Prepared for: VILLAGE OF HOMER GLEN
14933 S. Founders Crossing
Homer Glen, IL 60491

GLENVIEW WALK ESTATES
SUBDIVISION OBSERVATION REPORT

July 25, 2012

HR GREEN JOB NO. 86120056

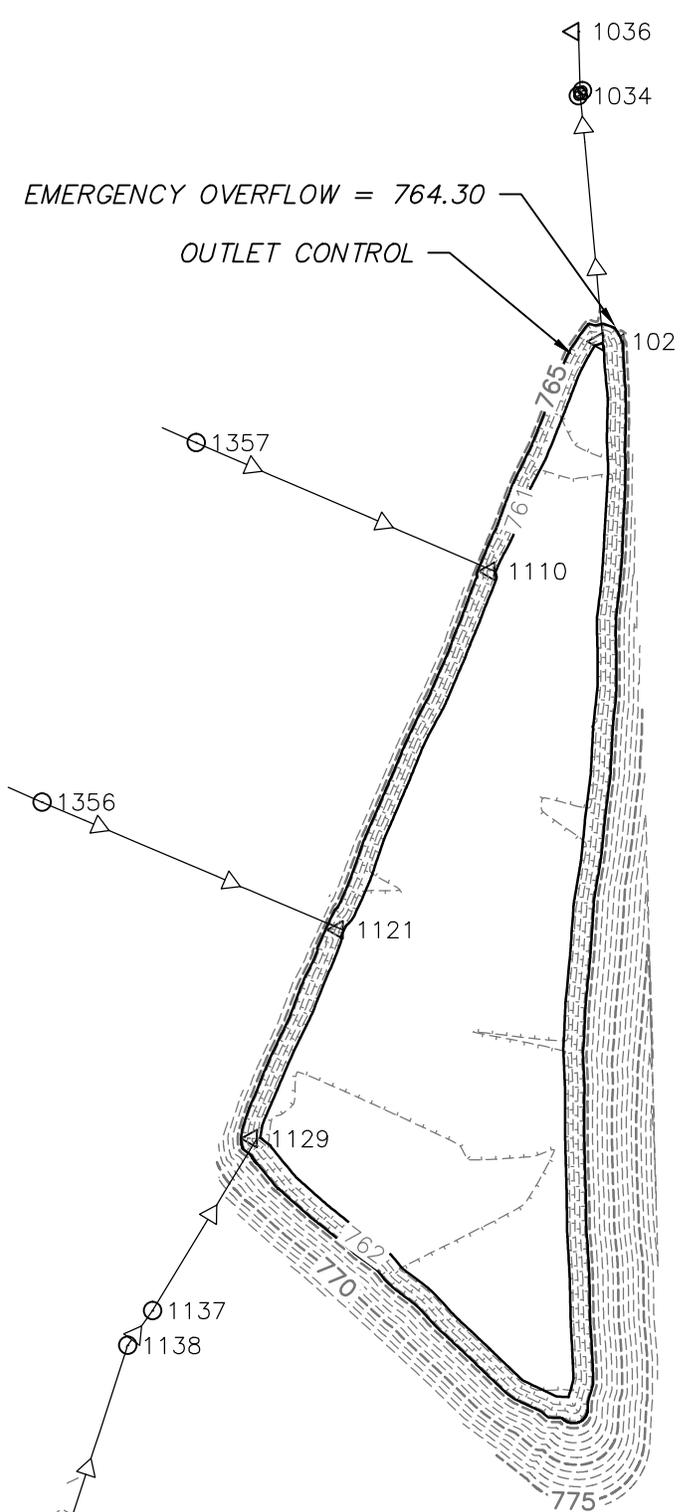
POND B			
	PROPOSED	EXISTING	DIFFERENCE
NWL (DRY BOTTOM)	762.00	763.60	1.60' HIGH
HWL	767.80	767.70	0.10' LOW
STORAGE VOLUME (AC.FT.)	4.4	3.12	1.28 Shortage

The outfall for Pond B was constructed 0.39' lower than required. This did not however impact the storage volume since our survey indicated that there is a ridge constructed right before the outfall that holds water back at an elevation of 763.60. This ridge raises the NWL of the pond by 1.6' and reduces the storage volume. The storage in this basin is further reduced by the elevation of the overflow structure #1205. The open grate is lower than the proposed HWL. We have assumed that the grate would restrict flow enough to allow the HWL to reach 767.7 (1'). The existing volume was calculated based on this elevation. This basin does not comply with the design plans. A detailed review of the

original drainage calculations or a hydraulic analysis would be required to determine the impact of these deviations.

POND A

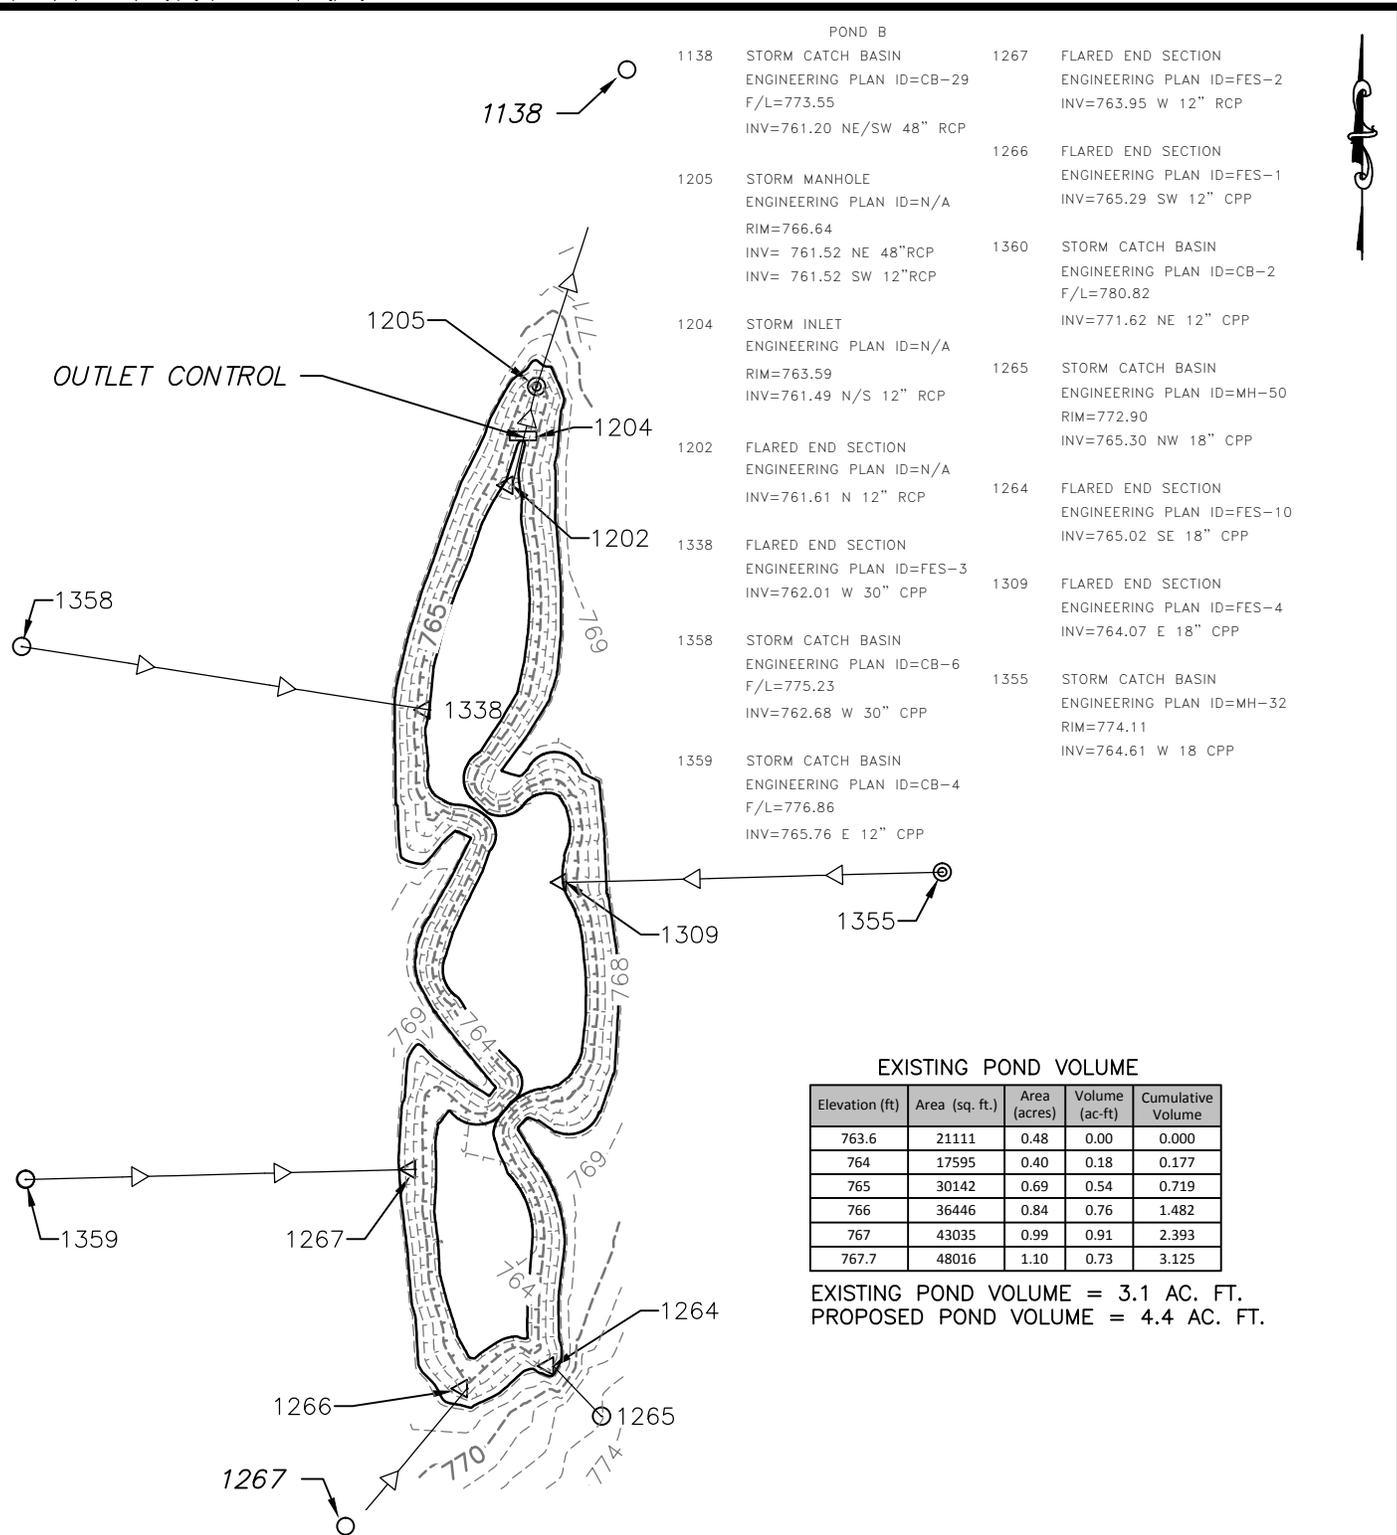
POND A			
	PROPOSED	EXISTING	DIFFERENCE
NWL	760.50	760.40	0.10' LOW
HWL	765.42	764.30	1.12' LOW
STORAGE VOLUME (AC.FT.)	11.23	8.66	2.57 Shortage

The restrictor for Pond A was constructed with a weir wall that can overtop at an elevation of 763.57 which is lower than the HWL. This will allow stormwater to be released at a rate greater than the allowable. This weir wall elevation was not shown on the proposed plans. The diameter of the 2 year restrictor orifice was constructed 1" smaller than was proposed. The 100 year emergency overflow was constructed 1.20' lower than the proposed elevation. This results in a reduced storage volume for the basin. This basin does not comply with the design plans. A detailed review of the original drainage calculations or a hydraulic analysis would be required to determine the impact of these deviations.

- POND A
- 1036 FLARED END SECTION
ENGINEERING PLAN ID=FES-9
INV=759.57 S 24" RCP
 - 1034 STORM MANHOLE
ENGINEERING PLAN ID=MH-27
RIM=764.67
INV=759.87 N/S 24" RCP
TOP OF WALL=763.57
ORFFICE_UPPER=762.17 9"
ORFFICE_LOWER=759.97 6"
 - 1102 FLARED END SECTION
ENGINEERING PLAN ID=FES-8
INV=760.32 N 24" RCP
 - 1110 FLARED END SECTION
ENGINEERING PLAN ID=FES-11
INV=760.41 NW 12" RCP
 - 1357 STORM CATCH BASIN
ENGINEERING PLAN ID=CB-26
F/L=767.52
INV=762.47 SE 12" CPP
 - 1356 STORM MANHOLE
ENGINEERING PLAN ID=CB-15
F/L=772.07
INV=761.07 E 30" CPP
 - 1121 FLARED END SECTION
ENGINEERING PLAN ID=FES-7
INV=760.34 NW 30" CCP
 - 1129 FLARED END SECTION
ENGINEERING PLAN ID=FES-6
INV=760.97 SW 48" RCP
 - 1137 STORM CATCH BASIN
ENGINEERING PLAN ID=CB-28
F/L=773.34
INV=760.99 NE/SW 48" RCP

EXISTING POND VOLUME = 8.66 AC. FT.
 PROPOSED POND VOLUME = 11.23 AC. FT.
